BLOOMINGTON HISTORIC PRESERVATION COMMISSION

Thursday February 13, 2014

AGENDA

HOUSE REMODEL FOR:
JEFF MEASE
 406 S MADISON
 BLOOMINGTON IN 47404

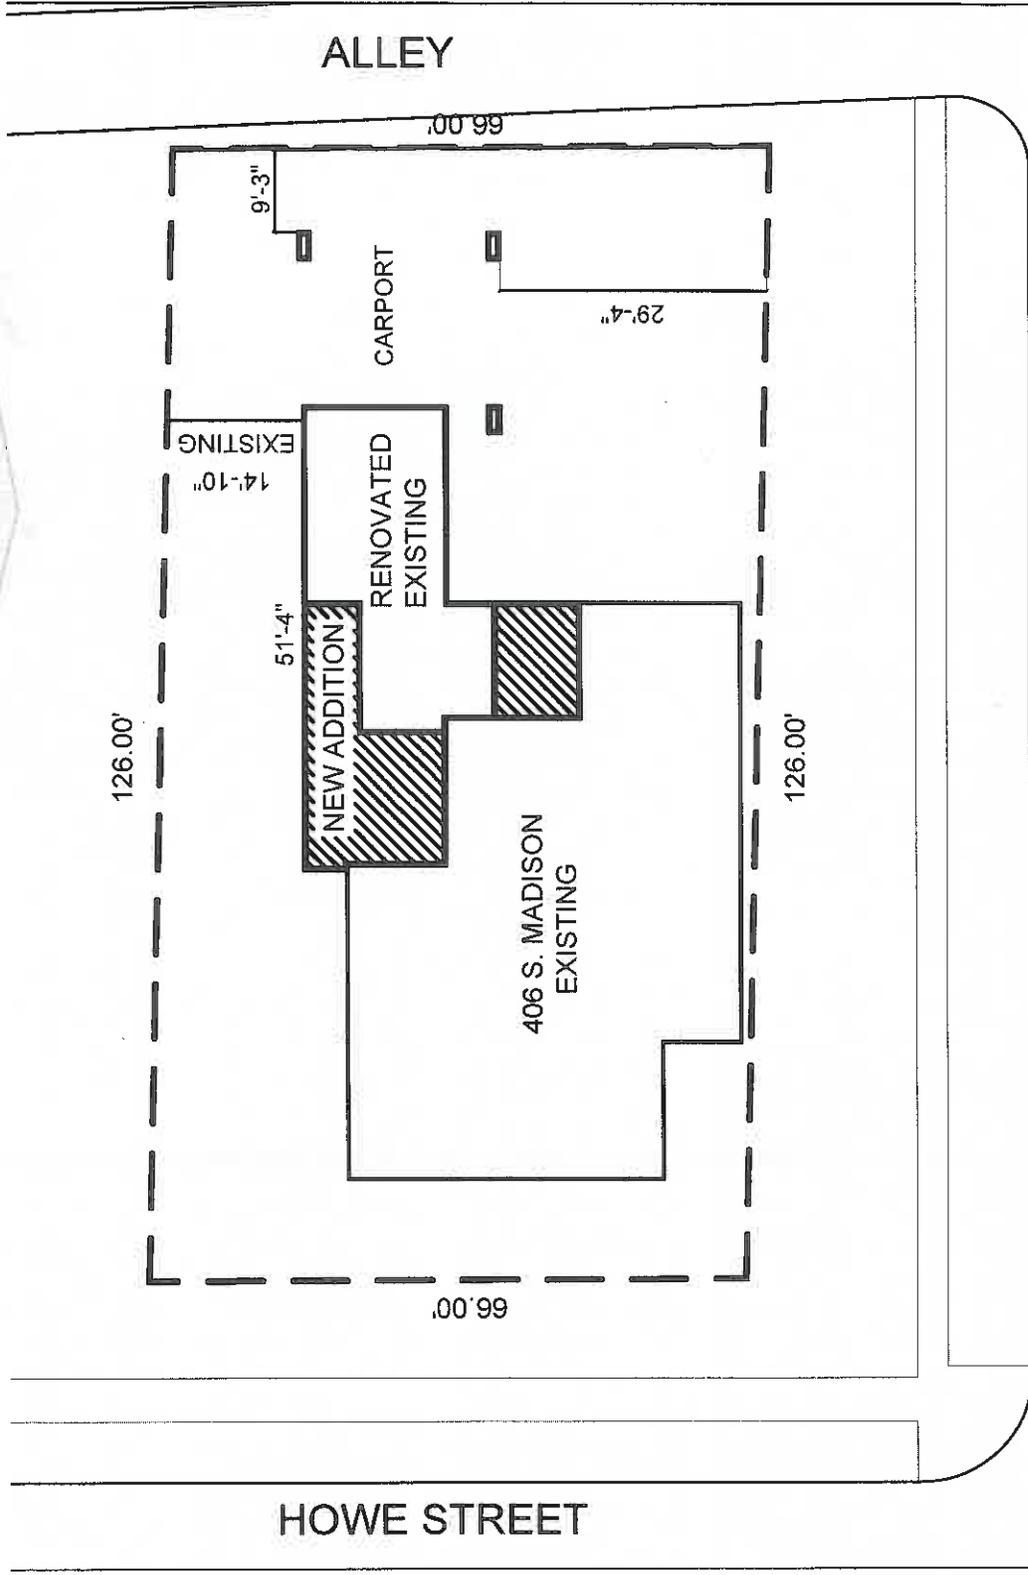
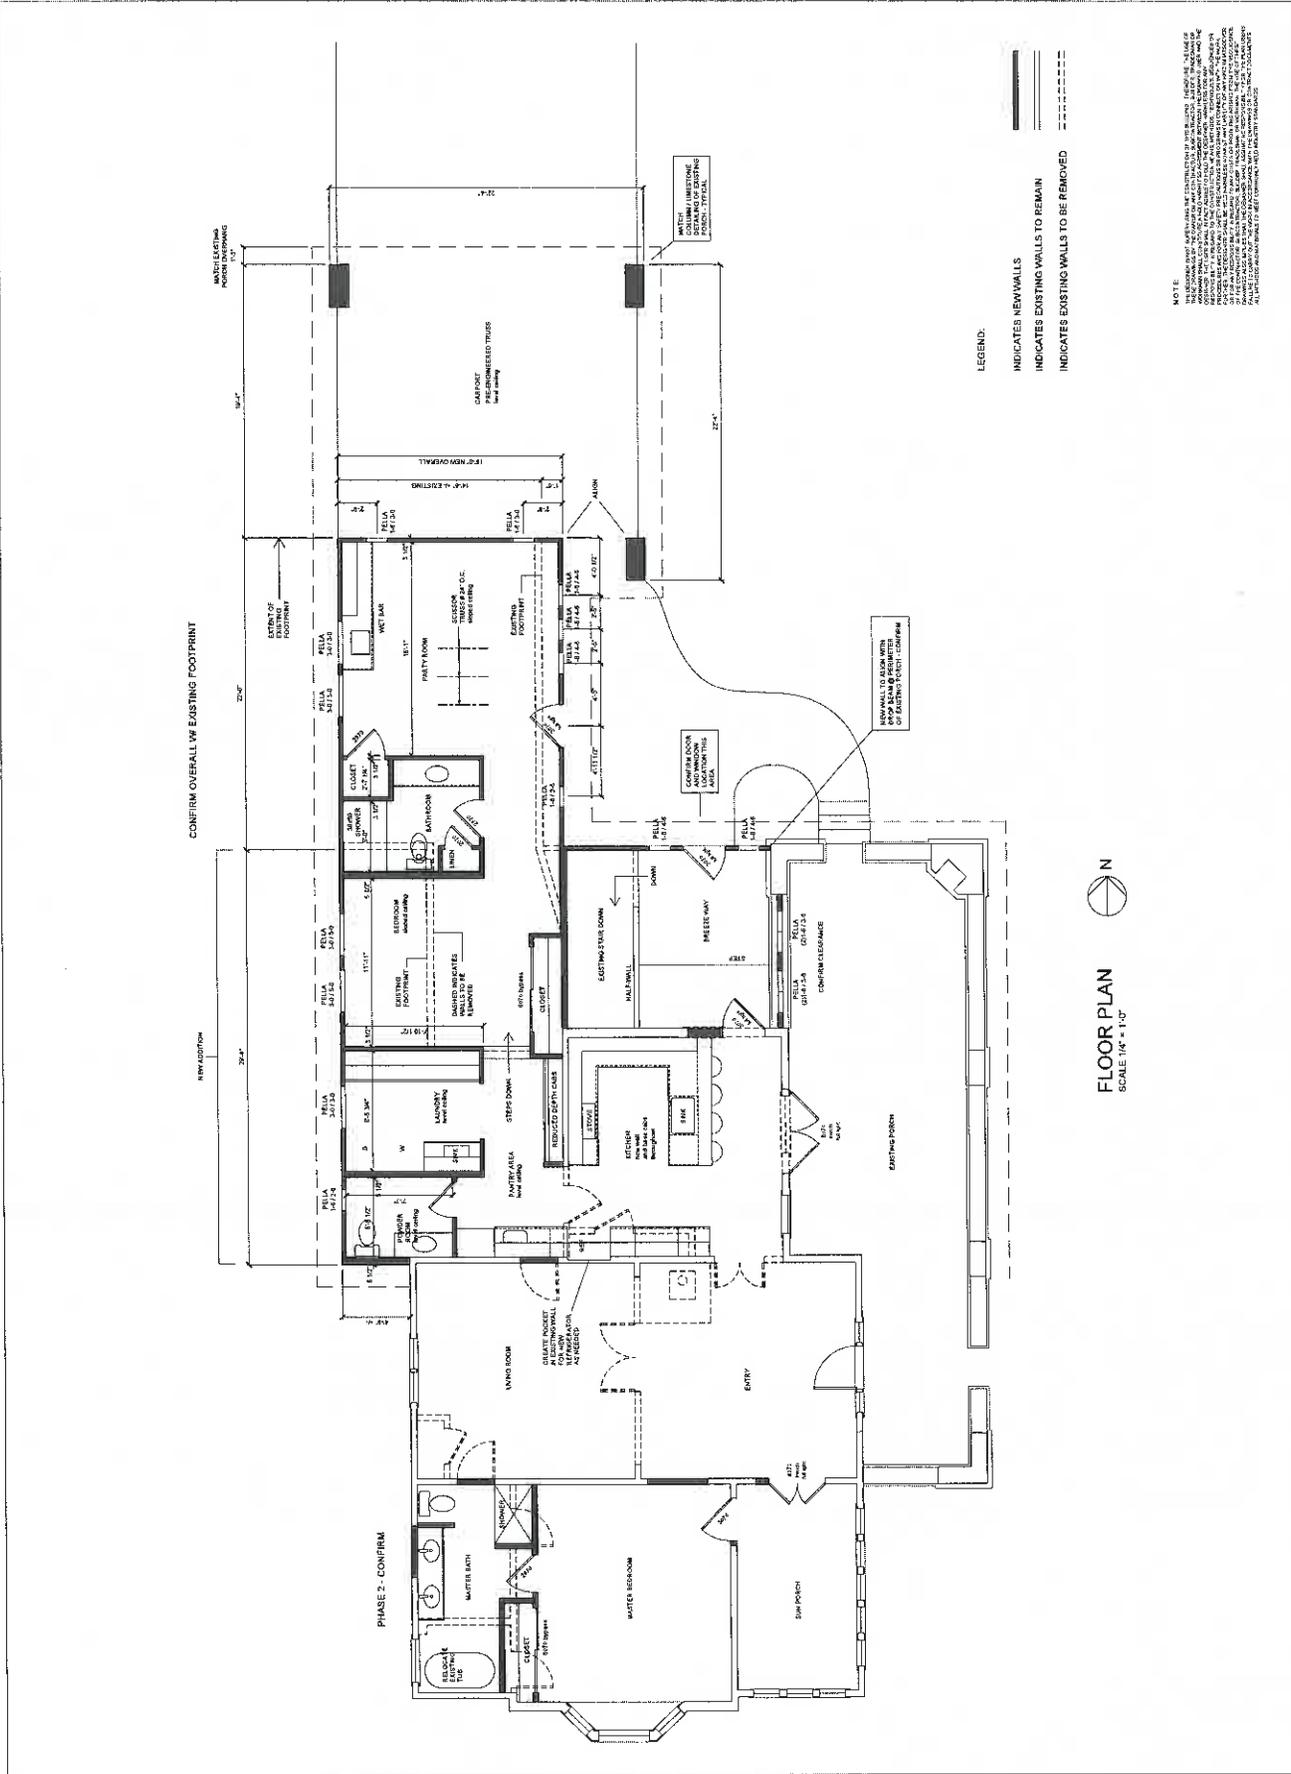
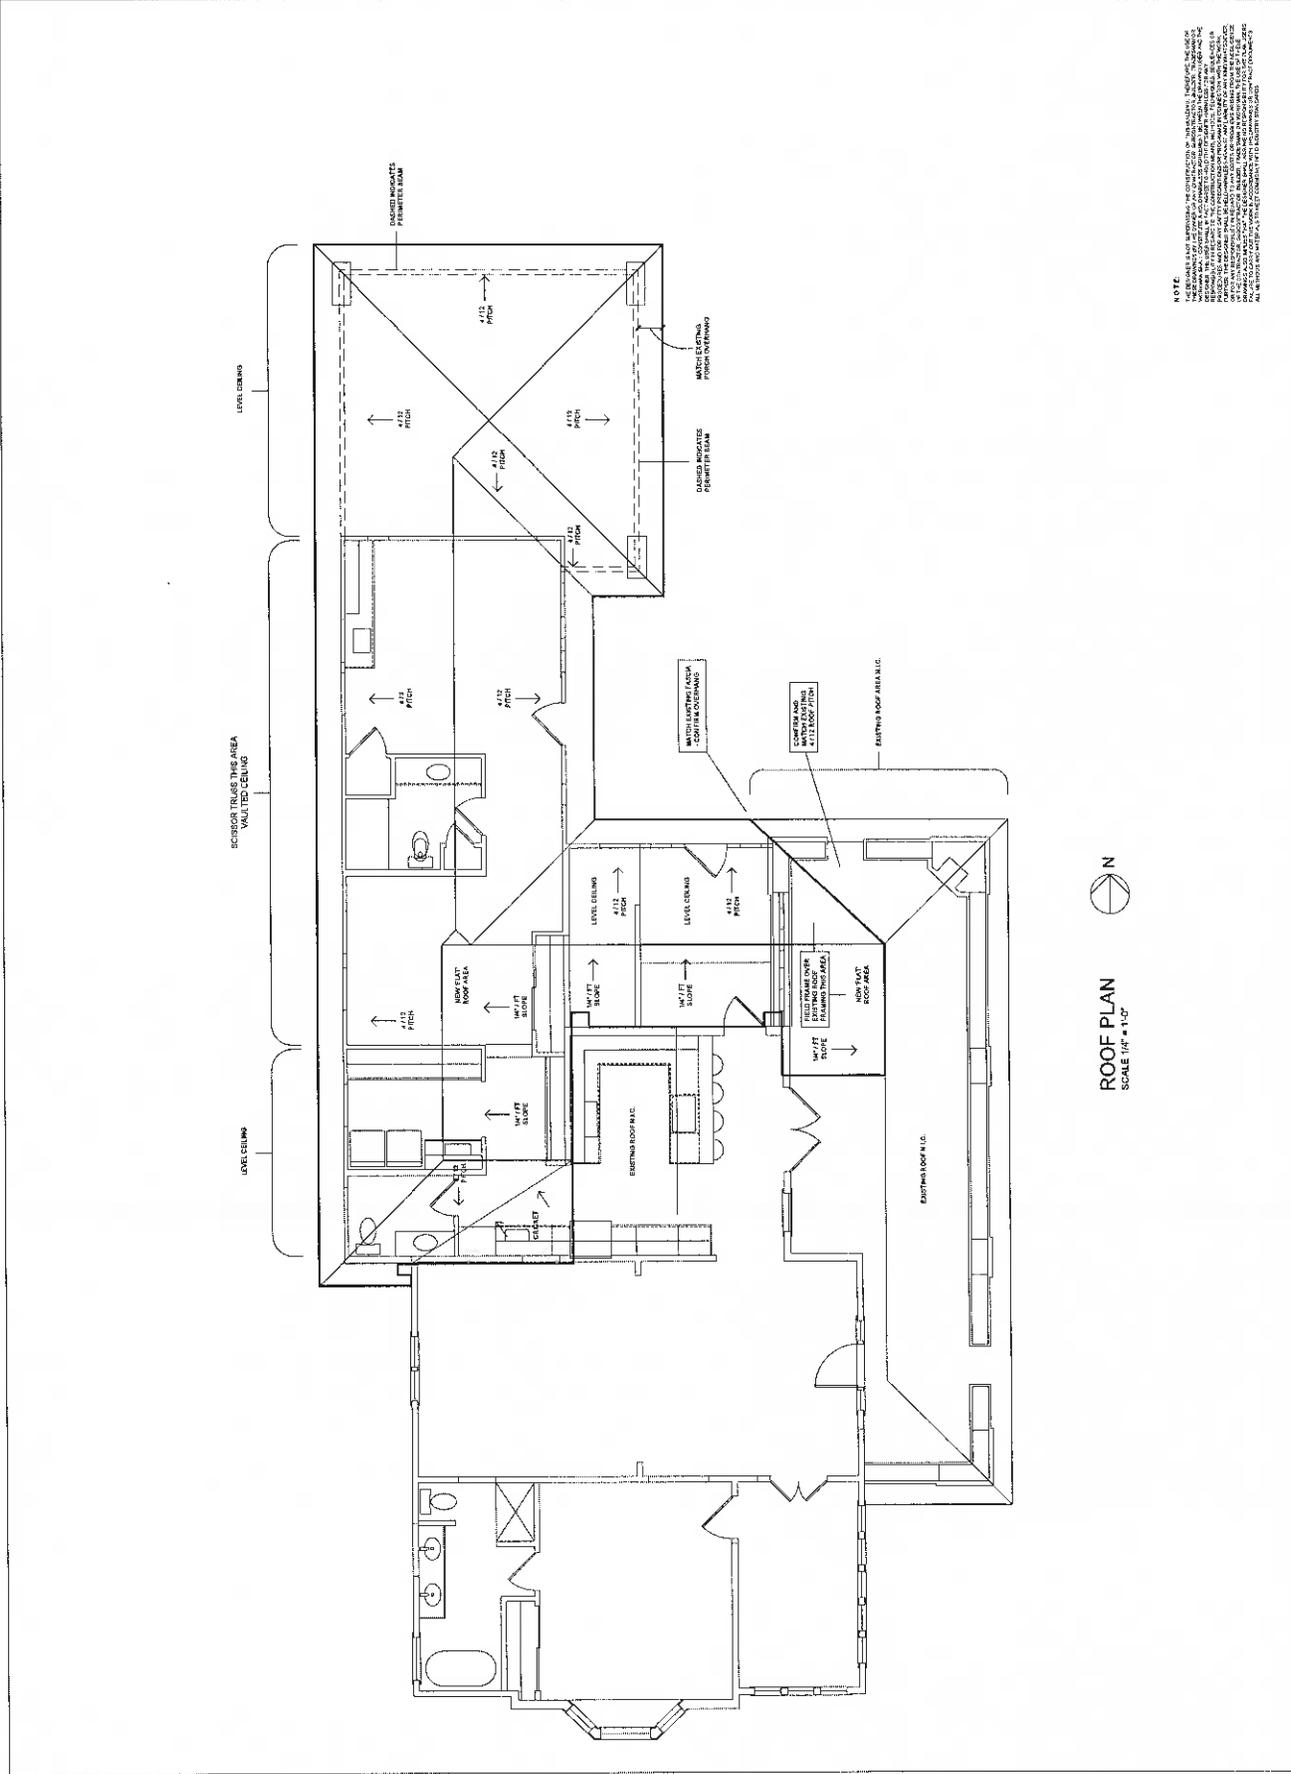
The owner is asking for a modest addition to the square footage (474 square feet) of the house which will replace a portion of the existing house at the rear and to add a porte cochere or car port. The reconstruction along the rear or west elevation of the house will create a straight wall with 5 windows, where a bump out existed before (photo E). This area should not be visible at all. The "breezeway" to the shed addition, previously discussed, will be re-roofed in order to connect the hipped carport roof to the previous shed. So an offset gable would become a simple gable connecting to the hipped roof. There is currently no covered car storage on the lot. The porte cochere is 450 square feet or 28' x 11' and the drive will connect directly to Smith. The columns will be the same rusticated limestone that was used on the porch.

An area directly behind the front porch will be enclosed (photo B). It will cover an existing stairwell. The space will be enclosed in windows, some of which may be visible through the porch structure.

This building definitely has a horizontal sprawling disposition on the lot which is continued with these new plans. The low hipped roof on the carport masks the size of the structure and keeps the additions secondary to the gabled house.

Staff is comfortable with this design which brings together some of the newer work on the house with the practical need for new kinds of space. Because the carport is designed into the plan with the use of limestone, its scale should be less obtrusive. The basic form of the historic house has been obscured for many years. Hopefully future work will bring it out more prominently.
